DETROIT EDISON-FERMI 2
 AUTOMATED RECORD MANAGEMENT
 DISTRIBUTION CONTROL LIST
 01/17/90

LCR 89-239-1UFS

PART 1: UFSAR, PLAN, OR PROGRAM REVISION [] NA

LCR 89-288-UFS REV. 0
 UFSAR FIGURE 9.2-4
 Pg 2 of 5

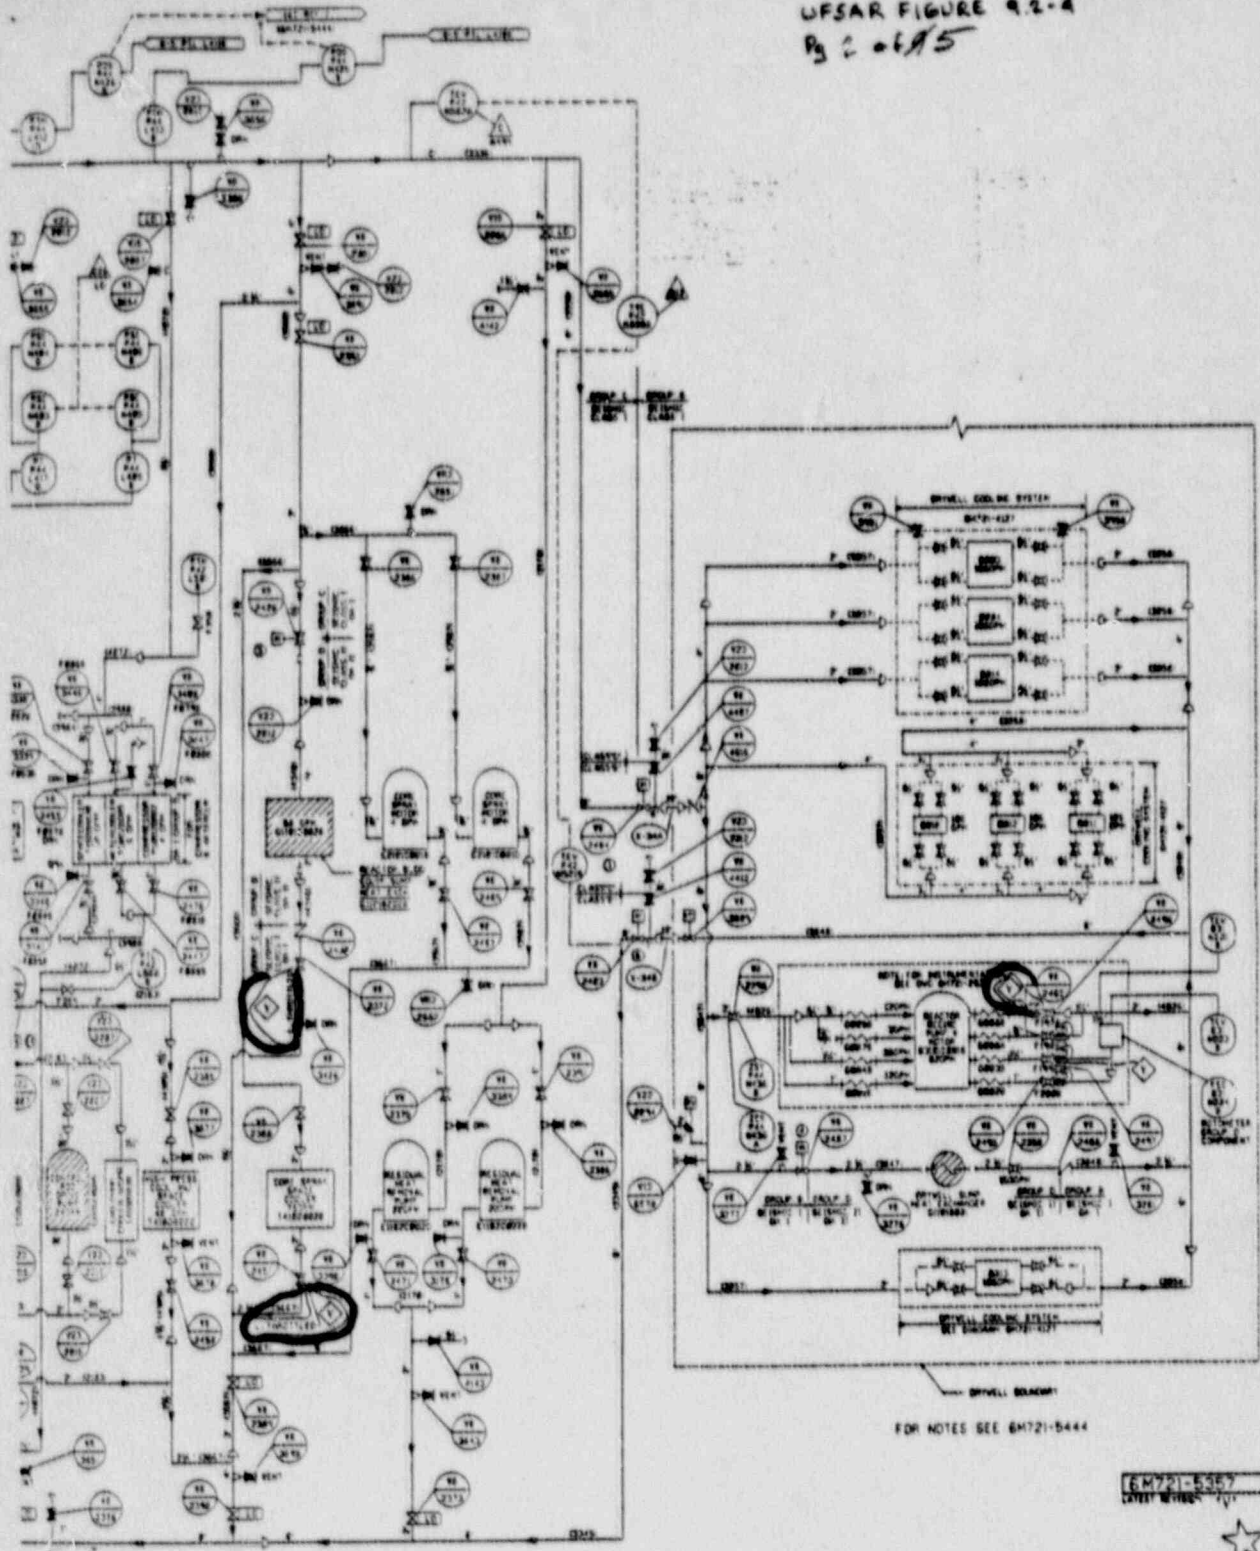
FIGURES 9.2-3 & 9.2-4

C) Reason for Change LOCKED VALVES

LCR 89-734-UF 5 REV. B
 PG 2 OF 109
 UFSAR FIGURE 5.1-3(SH 1)
 UFSAR FIGURE 7.3-12(SH 1)

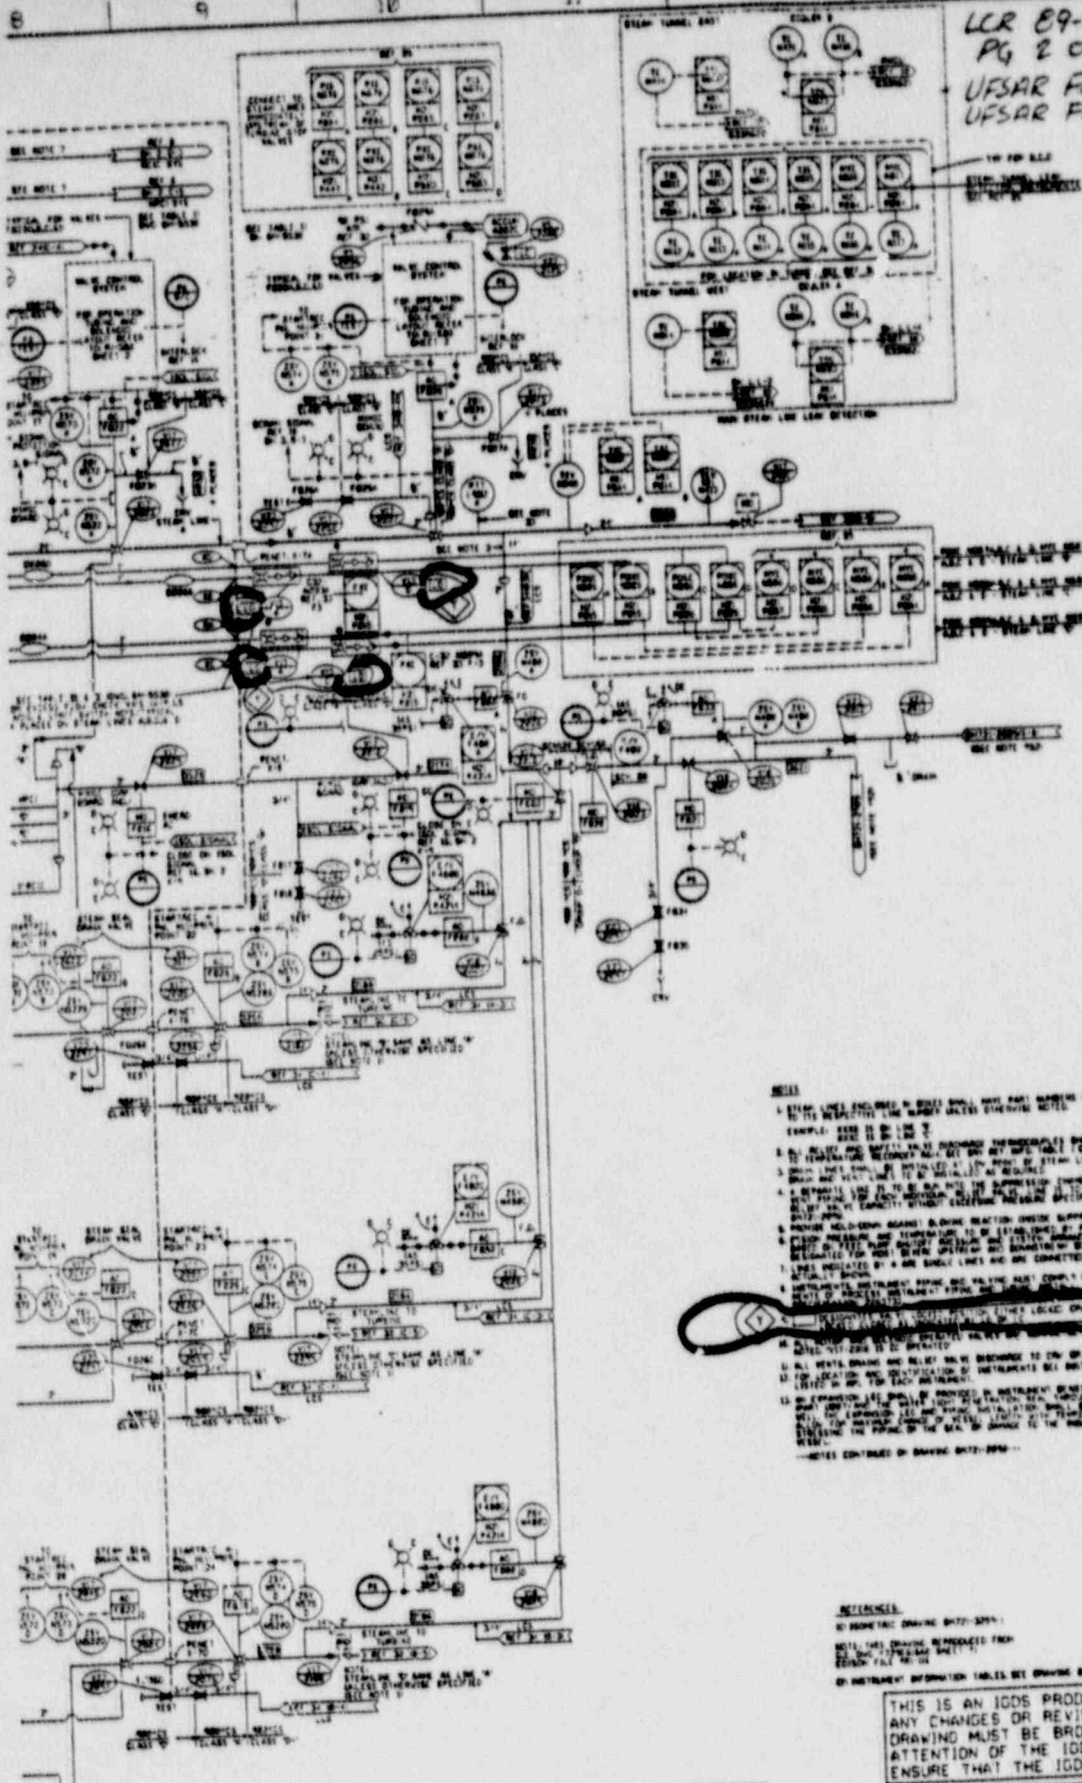
B) Section(s), Table(s), Figure(s), etc. Affected (Attach marked-up pages)
FIGURES 5.1-3(1), 5.1-3(2), 5.1-3(3), 6.2-27, 7.3-12(1), 7.3-12(2), 7.3-12(3)

C) Reason for Change LOCKED VALVES
60721-2089, 60721-2090, 60721-5538, 60721-2045, 60721-2089, 60721-2090

LCR 89-232-UFS Rev 0
 PG 2 OF 143
 UFSAR FIGURE 7.3-7

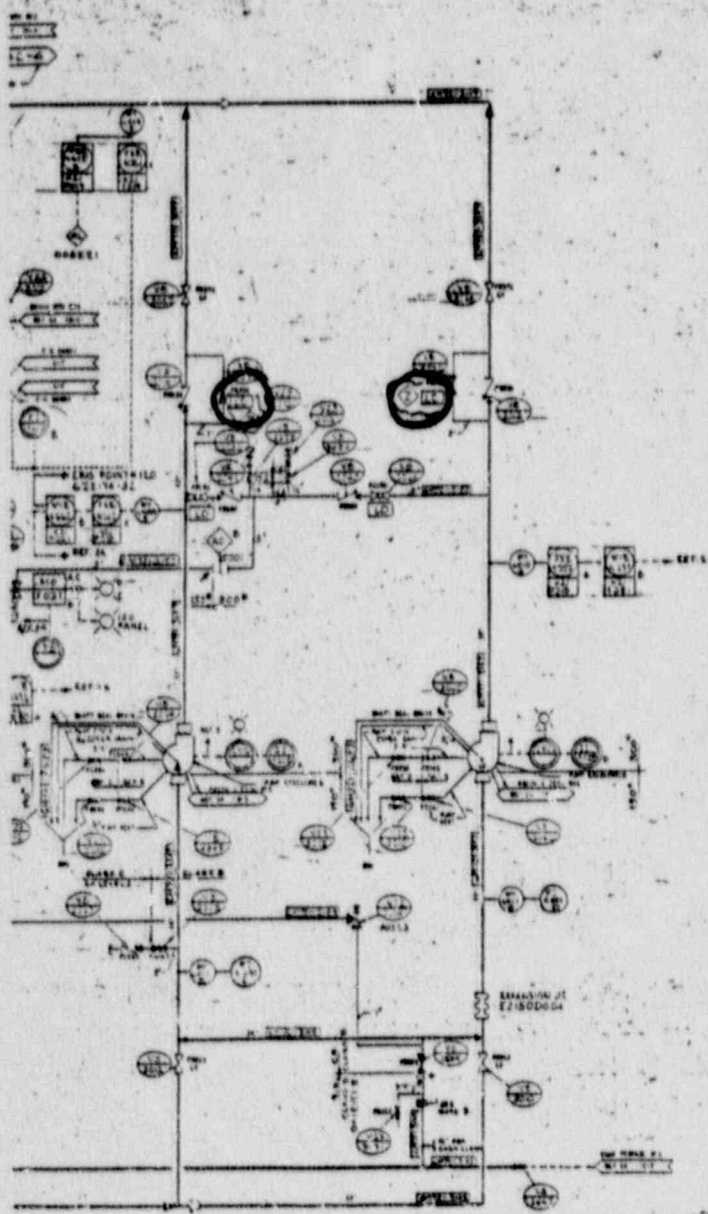
B) Section(s), Table(s), Figure(s), etc. Affected (Attach marked-up pages)
FIGURE 7.3-7 6032 2024

C) Reason for Change LOCKED VALVES

UCR 81-2317 UFS
 KEY 0
 PG 8 OF 5
 UFSAR FIG 5.5-13(1) (Cont)

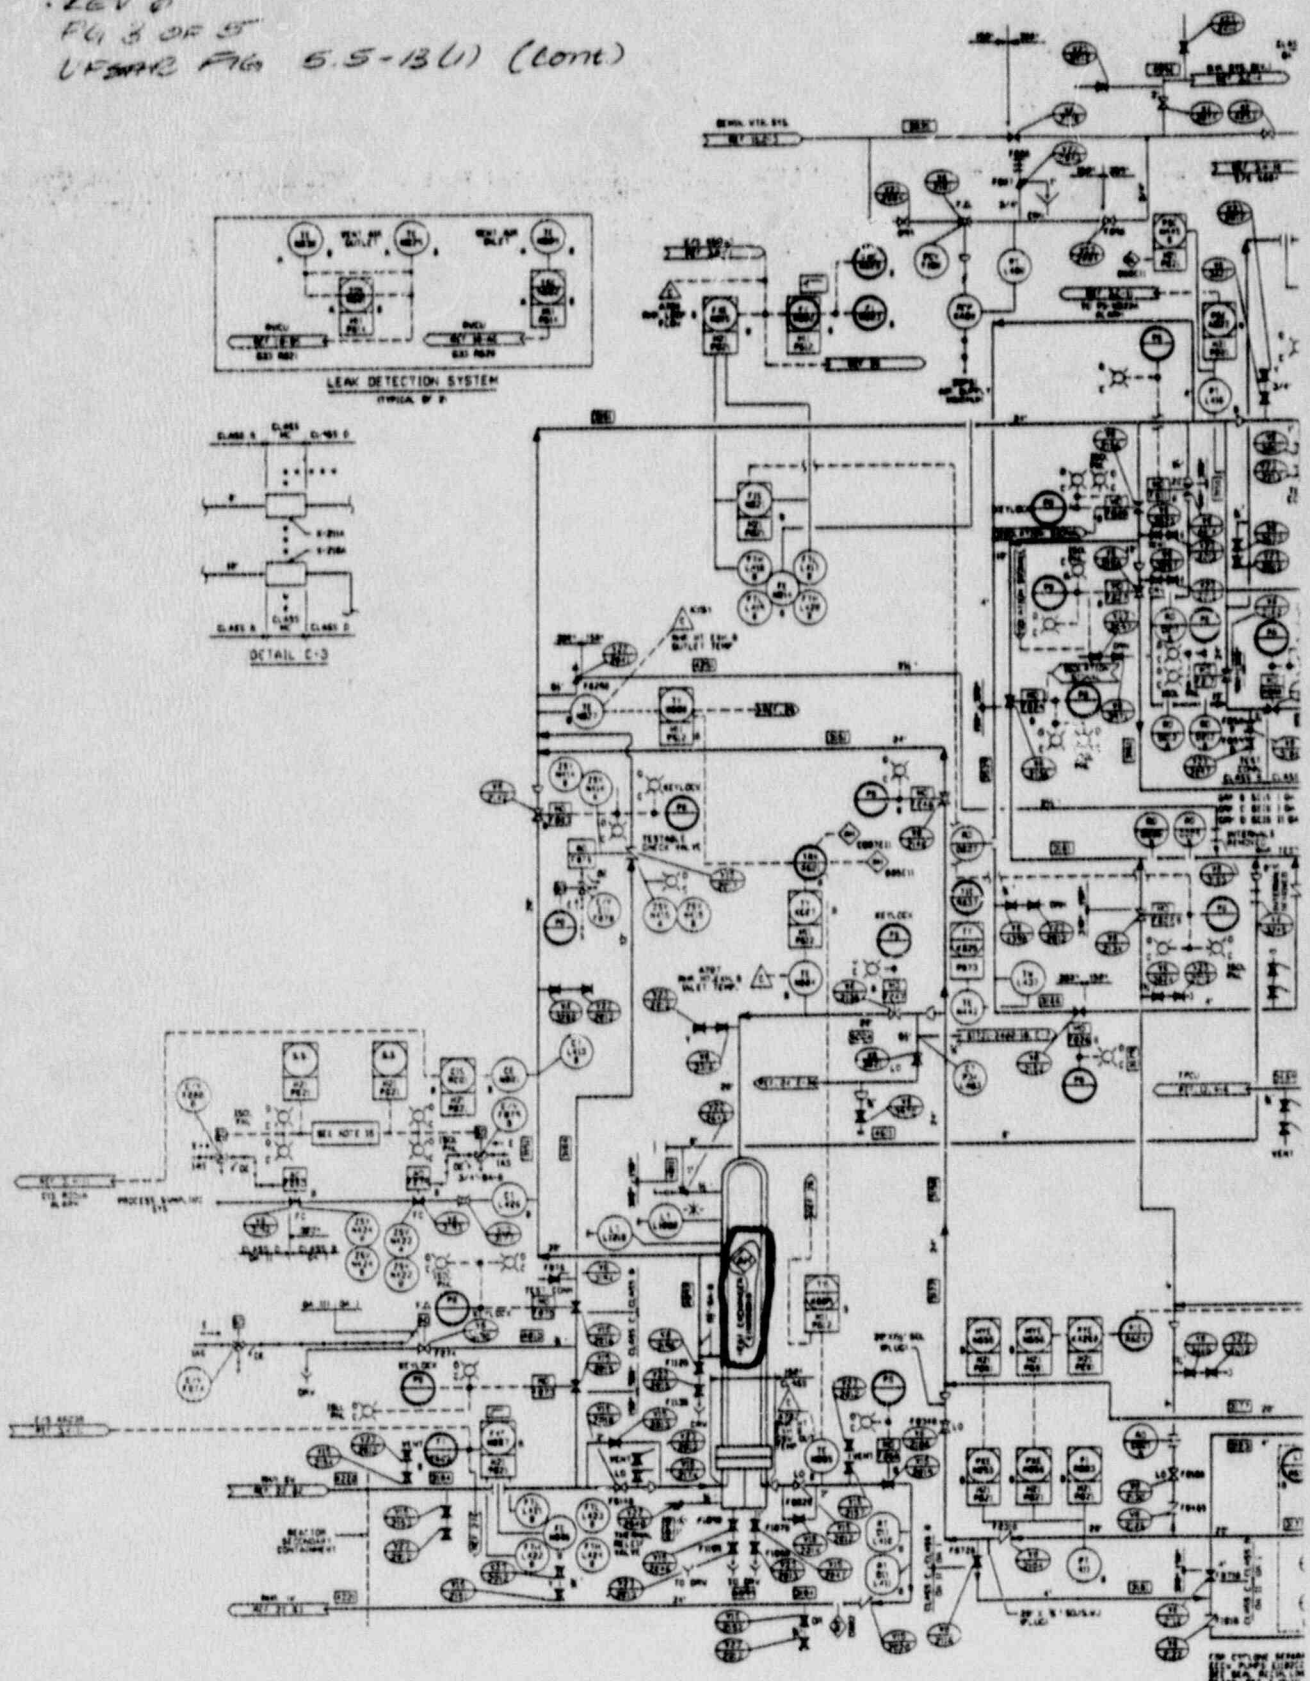
B) Section(s), Table(s), Figure(s), etc. Affected (Attach marked-up pages)
FIGURES 5.5-13(1) & 5.5-13(2) 60721-2083, 60721-2084

C) Reason for Change LOCKED VALVES

LCC 81-230-UFS
 Rev 4
 PG 3 OF 3
 UFSAC FIG. 5.52-SM-1
 (CONT)

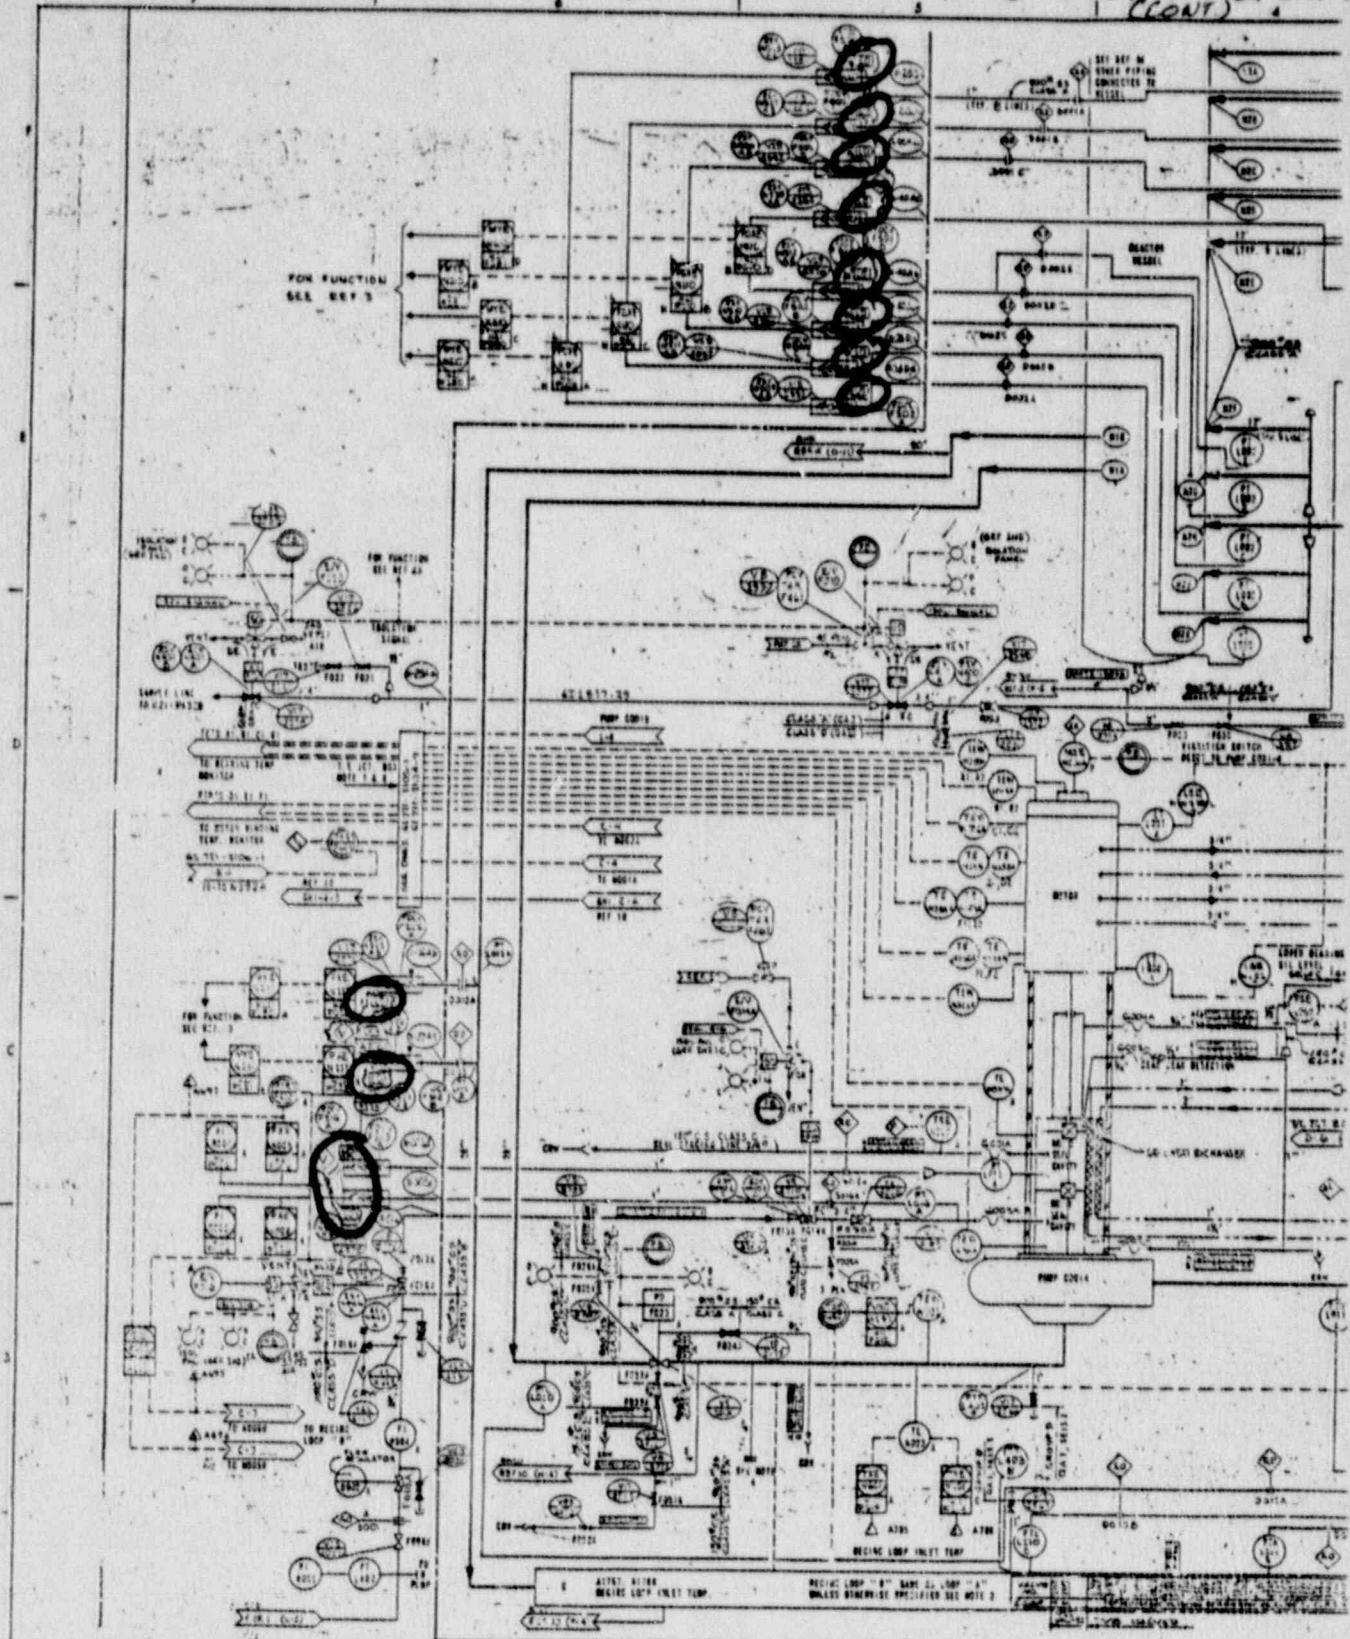
FIGURE 5.5-2(1) GM 791-2833

C) Reason for Change LOCKED VALVES

LCR 89-225 - UFS ~~Rev. 0~~
 UFSAR FIGURE 6.2-20
 Pg 2 of 6 ~~9~~ ~~10~~
 5-7

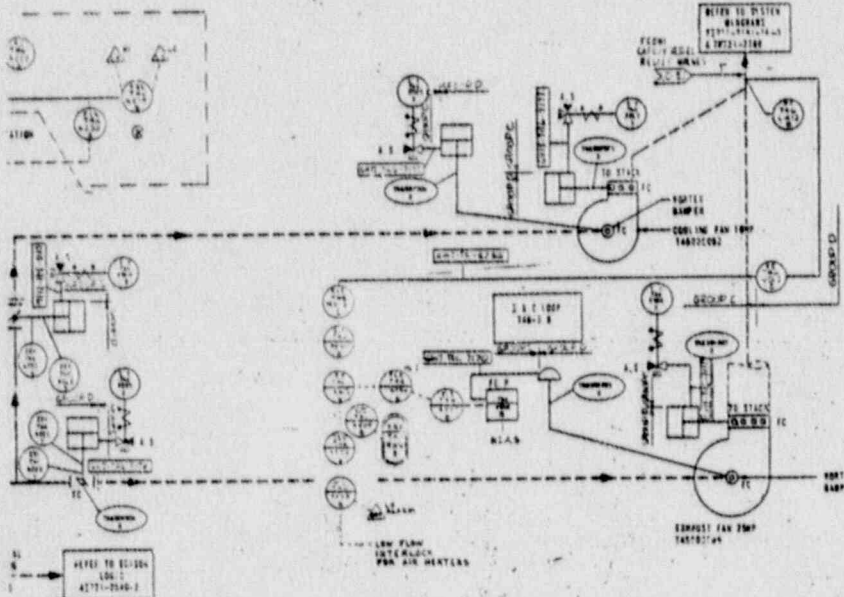
B) Section(s), Table(s), Figure(s), etc. Affected (Attach marked-up pages)
FIGURE 6.2-20

C) Reason for Change TO SHOW VALVES IN THEIR NORMAL OPERATING POSITION.

Section/Page	Change	Basis
UFSAR FIGURE 6.2-20	SHOW VALVES T4600- F021A, F021B, F022A AND F022B IN THE CLOSED POSITION.	IN THE NORMAL PLANT OPERATING CONFIGURATION THESE VALVES ARE CLOSED. THE VALVES ARE OUTBOARD ISO- LATION VALVES ON THE FILL AND EQUAL- IZING LINES FOR CARDOX VESSELS T46002001 & T4600- 2002 AND ARE OPENED ONLY DURING CARDOX VESSEL FILLING OPERATIONS. SHOWING THESE VALVES AS CLOSED WILL NOT AFFECT THE OPERATION OR PERFORMANCE OF THE FIRE SUPPRESSION OR STANDBY (CONT'D, PG. 9)
